CCF4-06-033 B EXHAUST & CCF4-06-9001 MOUNT UPDATE

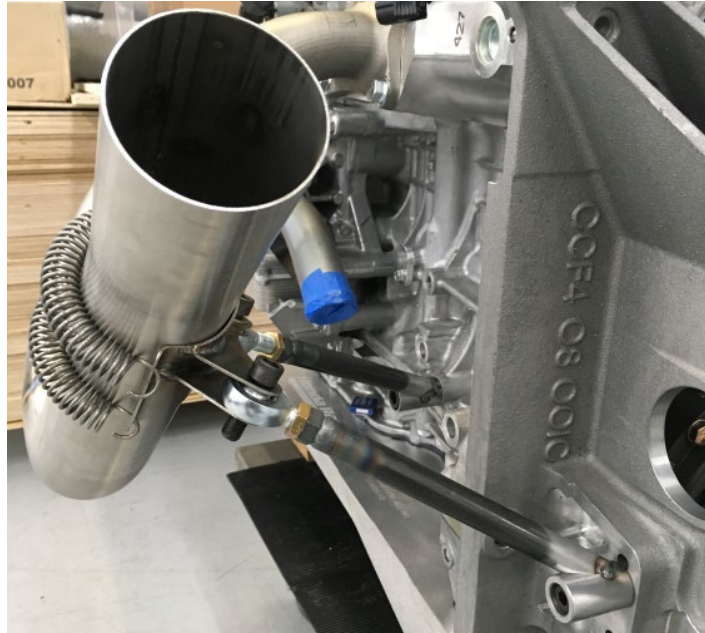
A revised exhaust and corresponding mounts have been produced to increase longevity and will be available starting at Road Atlanta.

The exhaust bracket is now adjustable via two points.

The previous version of the exhaust and its mounts will no longer be available or supported.
